ALERT SERVICE BULLETIN

SUBJECT: **REVISION "A" TO ALERT SERVICE BULLETIN 206L-05-136:
CLEVIS ASSEMBLY – HYDRAULIC SERVO ASSEMBLY, PART
NUMBER 41001520**

NO. 206L-05-136

SUBJECT: CLEVIS ASSEMBLY – HYDRAULIC SERVO ASSEMBLY, PART NUMBER 41001520

Clevis Assembly
 Figure 1

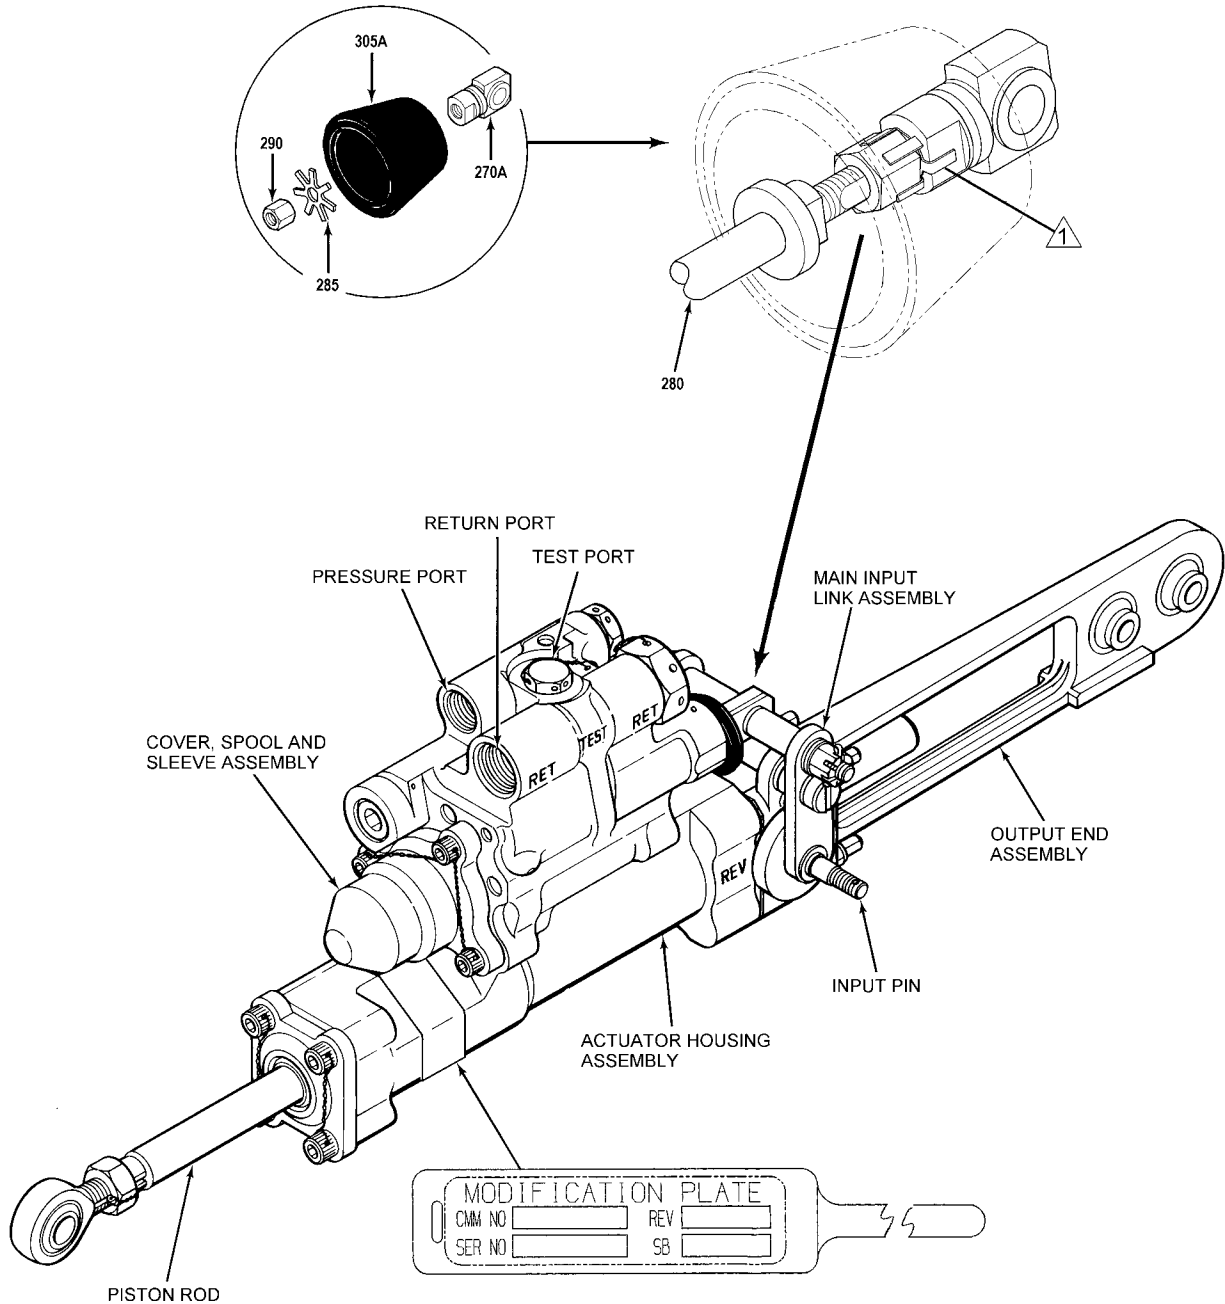
- The HR Textron Customer Service telephone number phone number, is added in Section 1, Step F.
- The compliance in Section 2, Step A, is changed.
- The inspection criteria are clarified in Section 2.
- HR Textron-Authorized Service Centers telephone and fax number are added in Table 1.
- A better graphic view of the proper installation is shown in Figure 1.

HR has discovered the possibility that the shaft (280) (refer to Figure 1) could be loose. The looseness is as a result of lock washer tabs (285), improperly bent over the flat surface of the nut (290) or the flat surface of the clevis assembly (270A).

3. If the shaft is not turning independently from the nut or the clevis assembly proceed with step 2.B.4.
4. Check if at least one tab of the lock washer is bent flush against one of the nut flat surface and if at least one tab of the lock washer is bent flush against one of the two flat surfaces of the clevis assembly. Lock washer tab must also be in line with the flat surface of the nut and clevis assembly. If the lock washer tabs are not bent flush against the nut and clevis assembly or are not in line with the flats, proceed with the following steps.

5. If the lock washer tabs are not bent flush against the nut or clevis assembly flat surface, use needle-nosed pliers and make sure the lock washer tab is flush against nut or the flat surface of the clevis assembly.

- 1 ACCEPTABLE CONDITION
 A MINIMUM OF ONE TAB SHALL BE IN LINE AND BENT FLUSH WITH THE NUT FLAT SURFACE AND A MINIMUM OF ONE TAB SHALL BE IN LINE AND BENT FLUSH WITH THE CLEVIS ASSEMBLY FLAT SURFACE
